Re: 16336 Shady View Lane, Los Gatos, CA

Project Name: Coulson Residence  
Project Address: 16336 Shady View Lane.  
Date: 06/11/19  
Response to neighbor concerns.

Project Name: Coulson Residence  
Project Address: 16336 Shady View Lane.  
Date: 07/03/19  
Response to neighbor concerns.

Re: 16336 Shady View Lane, Los Gatos, CA (the "Shady View Property")

Cover Sheet and  
Landscape Plan

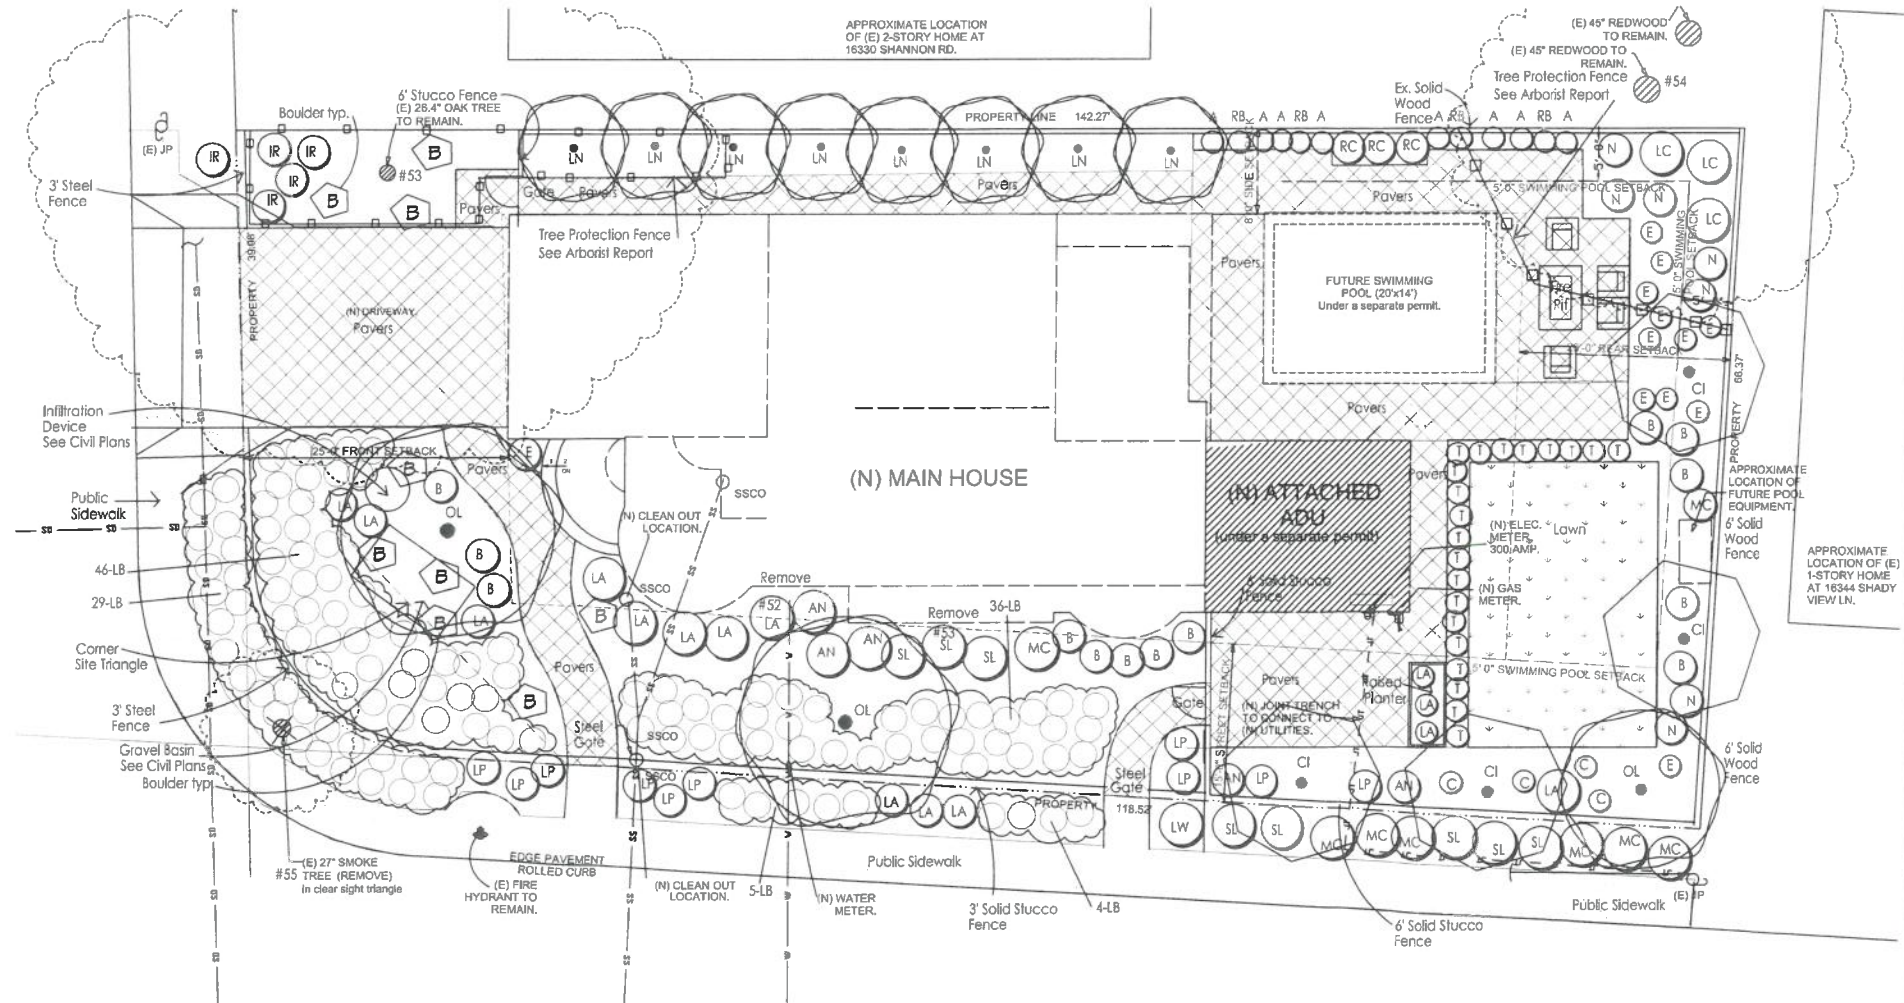
Unfortunately, the Coulson's landscape plans do not address the concerns covered in our June 13, 2019 letter to the Town that we reviewed with you and Sally Zarnowitz in our meeting on the same day.

We reiterate all of the same concerns stated in our June 13, 2019 letter. These include the lack relief from the massing of the side of the proposed home, windows that look directly onto our home and a proposed second floor balcony that peers directly down into our backyard from two angles. The Coulson's current plan appears to create a 26 foot shear wall 8 feet from our shared property line that runs the entire length of our home and extends at least another 10 feet beyond the back wall of our home. We have attached pictures showing the extension of the proposed project beyond the back of our home as well as the privacy destroying balcony.

- 1) Per city arborist consultant report dated 1/31/19 by Walter Levison, replacement trees for Cypress trees # 51 and #52 by four 24" box trees
- 2) The existing Smoke Tree in the city ROW is in the clear sight triangle and we would like to remove it. The canopy is between 10' and 25' dia which would require three 24" box trees according to the table on page 22 of the arborist's report
- 3) Total replacement trees are seven 24" box trees  
four 24" box Citrus  
three 24" box Swan Hill Olive

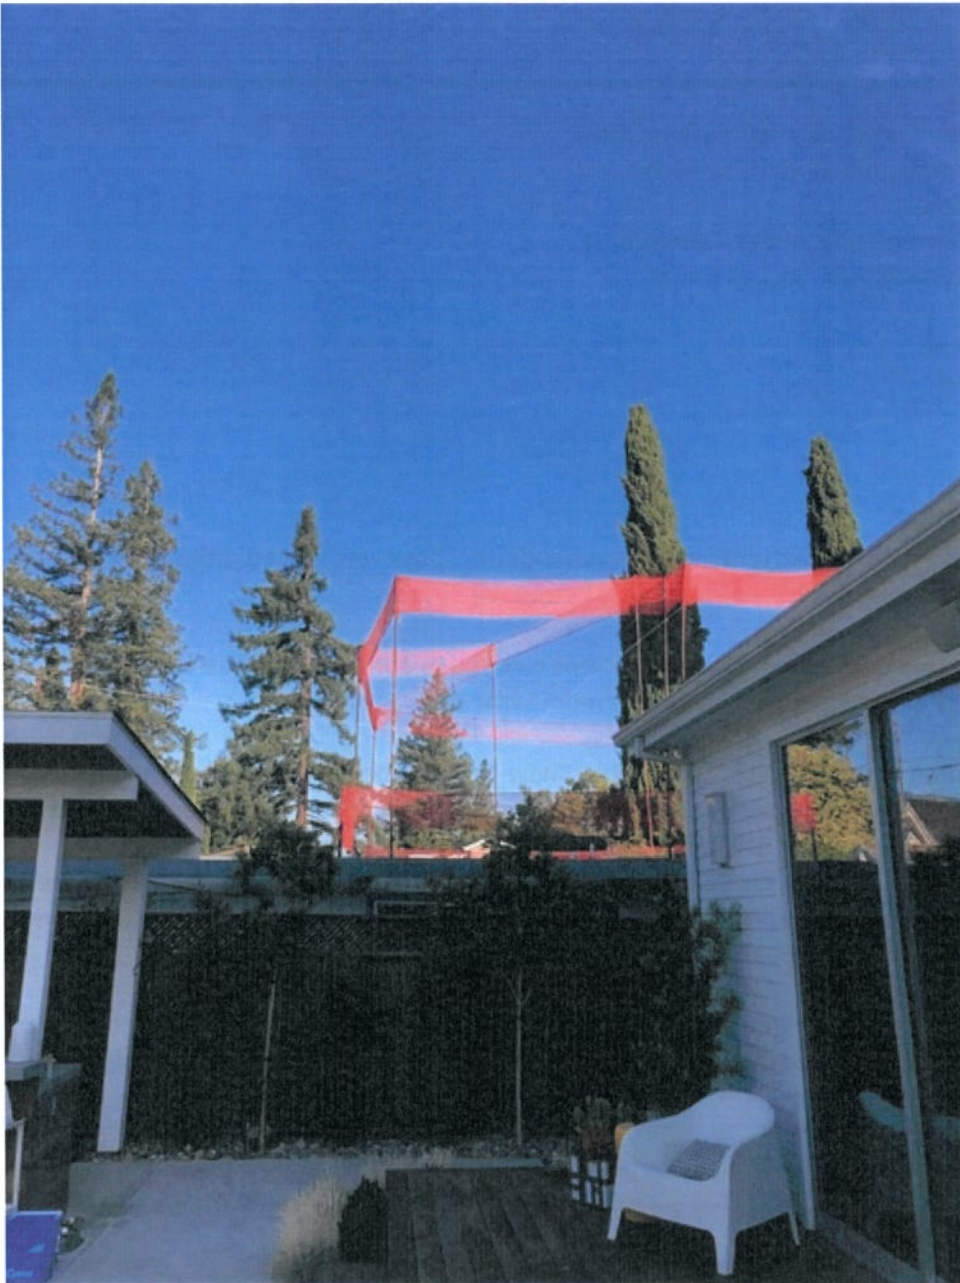
On June 27, 2019, the Coulson's erected story poles. Needless to say, we are taken back that by this development. We are shocked that the Town Architect, Town Planning Staff and developer, would not be more sensitive to the significant impact to our privacy that the current project creates.

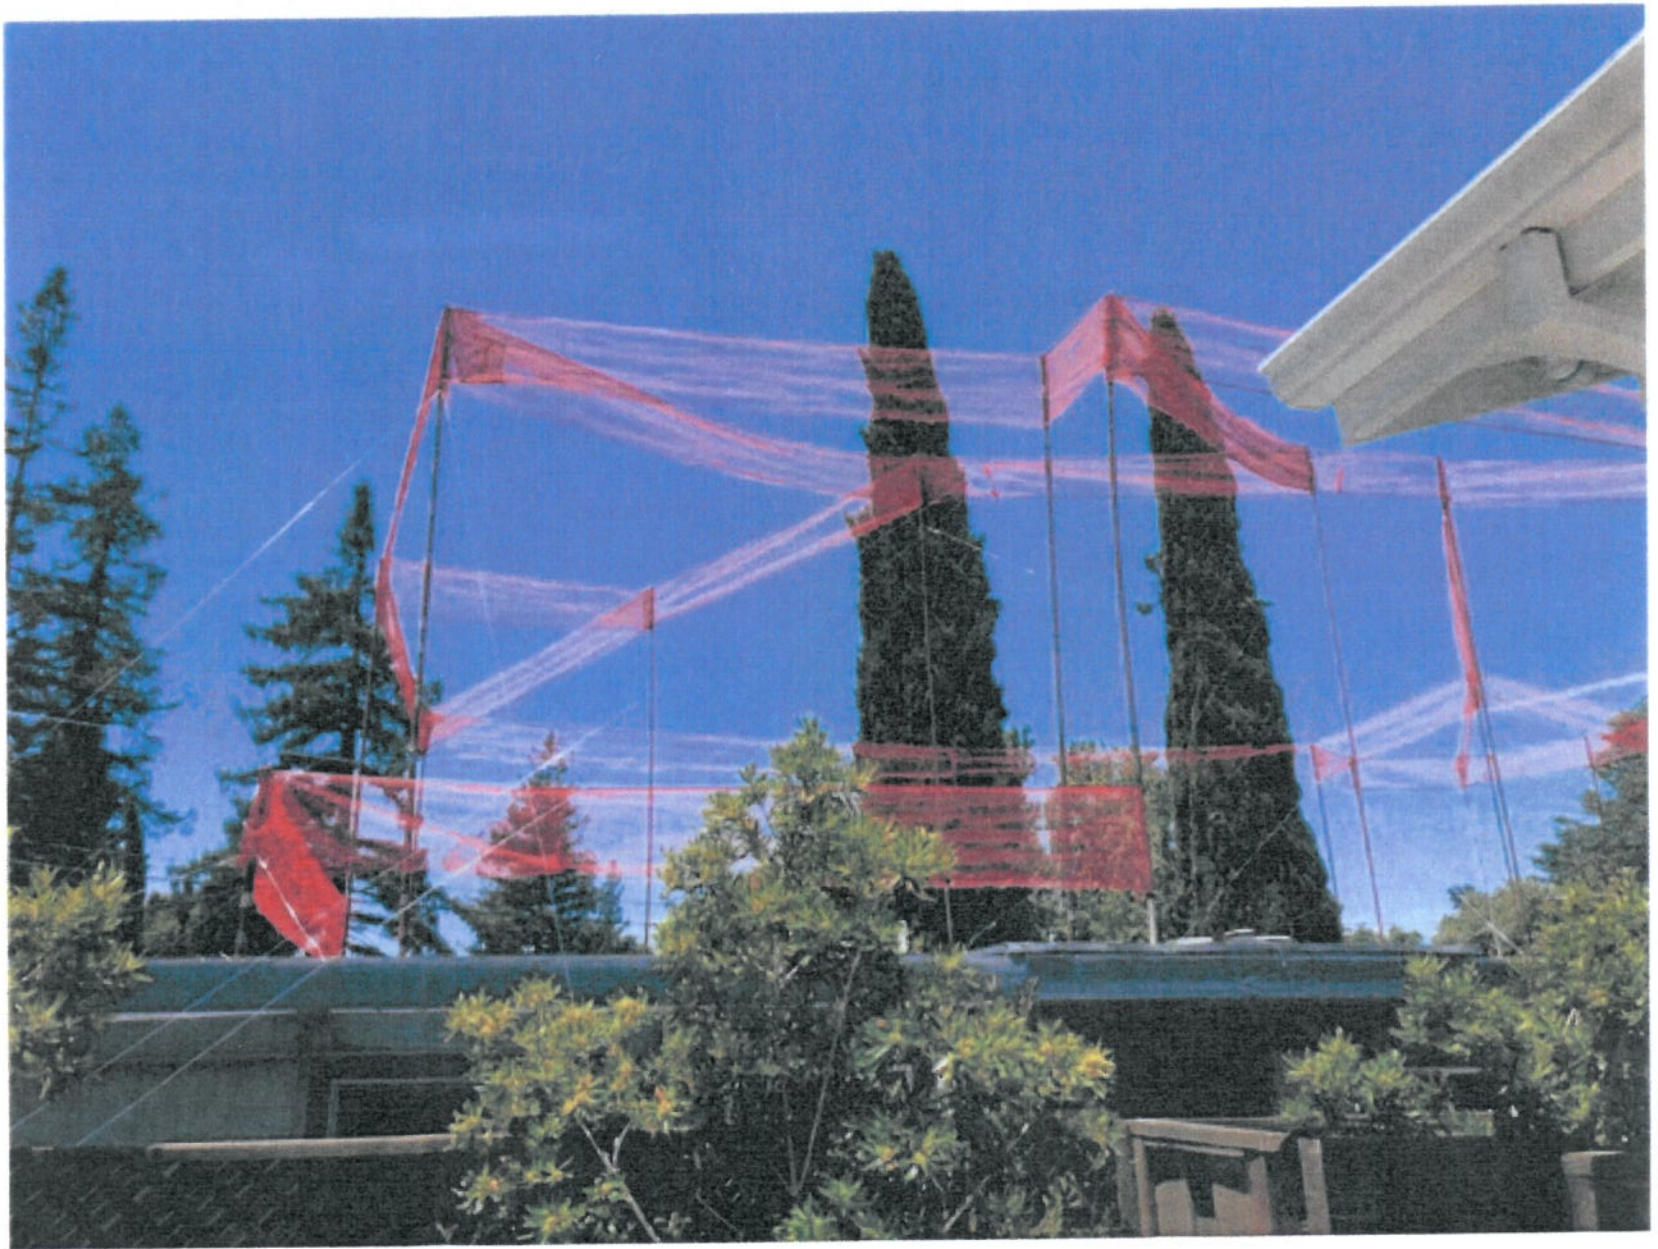
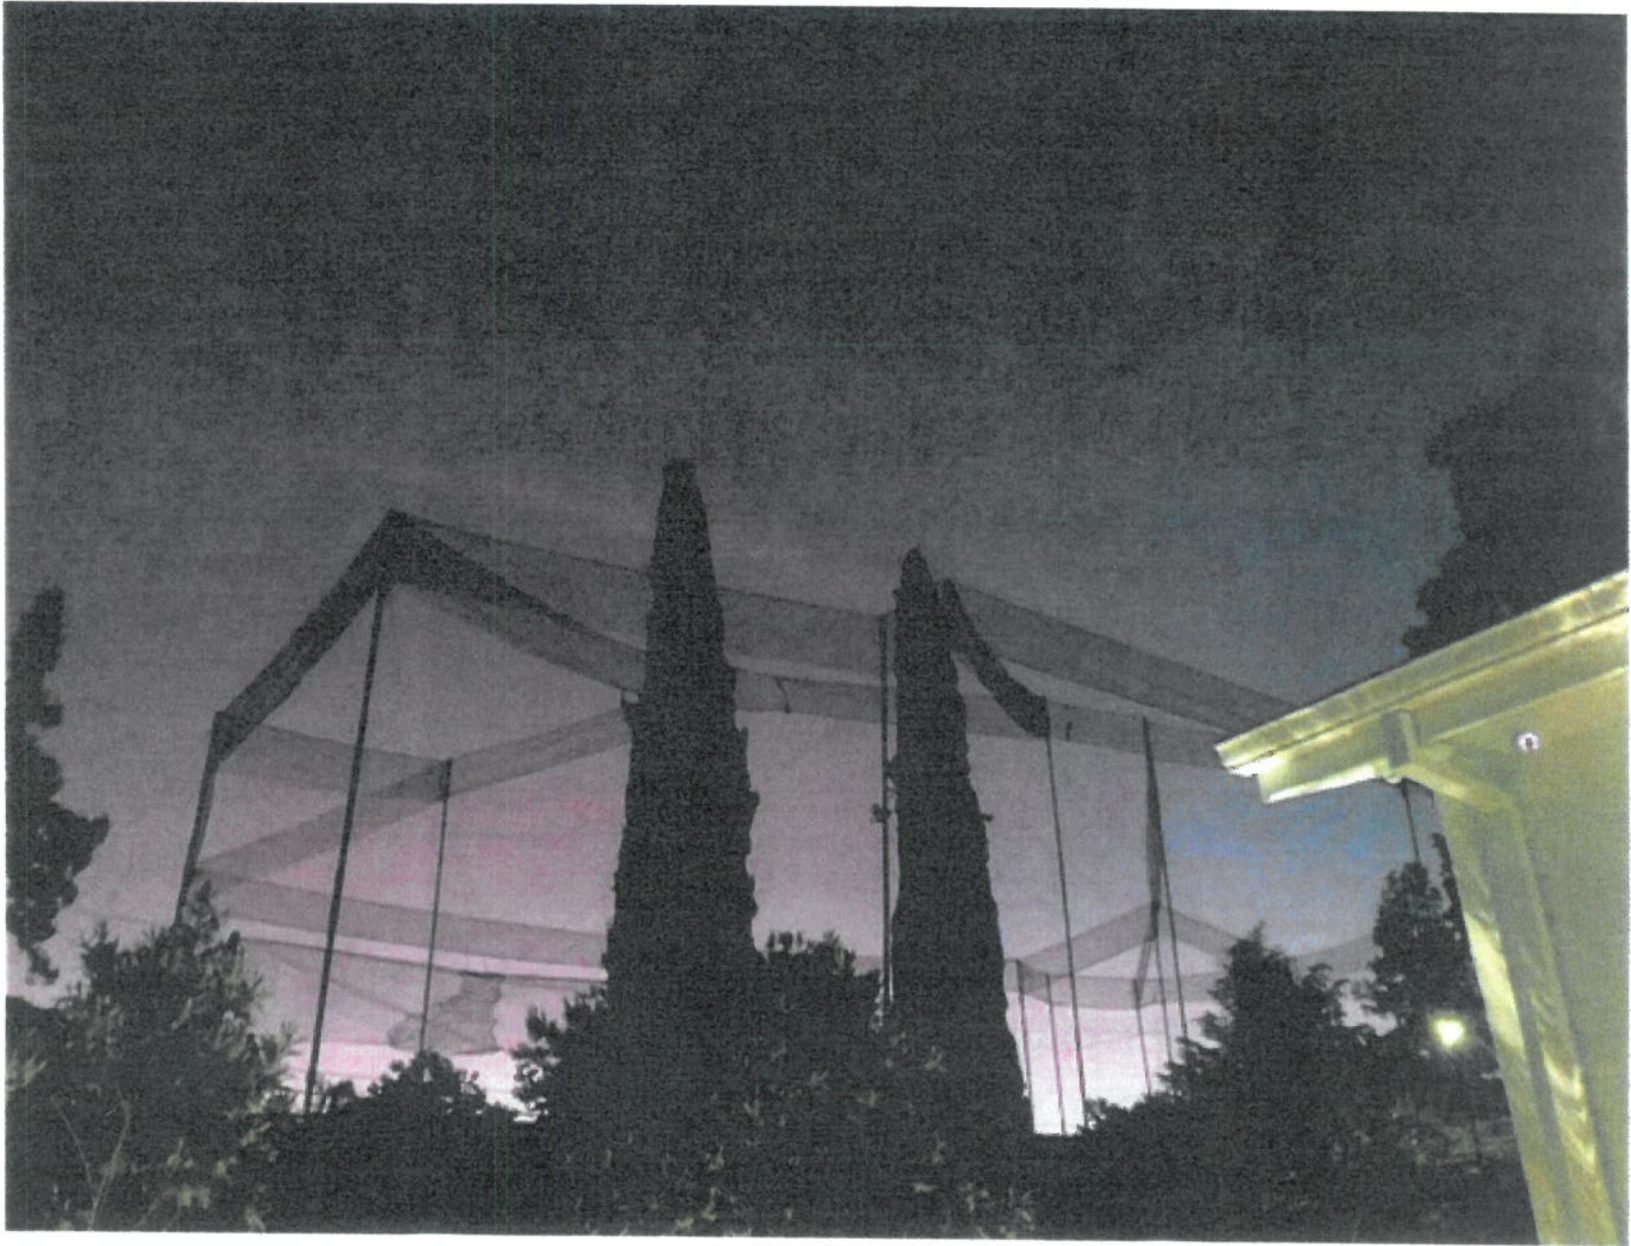
First, the second story rear balcony remains a significant privacy concern. Even with the relatively minor adjustments proposed in the July 18 letter, the proposed second-floor balcony still opens to views of our private living spaces from the rear of the proposed home. Since the balcony is perched at the far rear corner of the proposed home, it can be seen from nearly every area in our back yard. Please keep in mind that we designed our home to maximize year-round indoor/outdoor living, so the thought of our neighbors peering down onto our outdoor spaces is very problematic. This combined with the location of the balcony that hugs the side set back makes this element of the proposed home appear to be located in our backyard. I have included various pictures of this privacy-invading element. Again, we would like to remind the applicant, the developer and the Town of the following principals laid out in Section 3.11.2 of Town of Los Gatos' Residential Design Guidelines titled - *Minimize privacy intrusions on adjacent residences*. This section provides in part:

Next, the proposed plan indicates that there will be no less than 8 windows in second-story living spaces facing our home and yard. We request a reduction in the size and quantity of the windows

Since the massing on this side of the home is so impactful, we request that the applicant extend the 24-inch box privacy screening trees along our shared property line all the way to the edge of the redwood canopy. The applicant's enclosed plans incorrectly indicate that there will be 15-gallon screening trees. We also request that the Town require the applicant (at their cost) to install a 2-foot extension of the existing fence to bring the fence up to 10 feet. Another concern raised by the applicant's latest plan is a future swimming pool that edges precariously close to the canopy of the redwood tree. As you likely know, a redwood tree's root system is quite sensitive. We expect the Town and applicant to assume all liability for any damage to or from the redwood tree from and after pool installation.

In our continued effort to accommodate the requests of the neighbor we feel that, short of removing the balcony altogether, further changes to the balcony would compromise its purpose. Therefore, we are not comfortable making any further changes to the current design.

With respect to the windows; no less than half of the windows are located in an area which is open to the first floor some 15 feet below. The remaining windows were previously reduced in size and placed above eye level. And in the case of the bathroom window, shown as obscured. Therefore, we stand by the current design as it is proposed.

Speaking to the privacy screening trees; our last effort increased the size and number of trees thus extending the distance of the screen. Adding more trees to this screen would further compromise the sun exposure for the pool as well as the proposed hardscape area. Therefore, we are not comfortable making any further changes to the current design. The reference to 15-gallon trees is an obvious type-o and will be corrected.
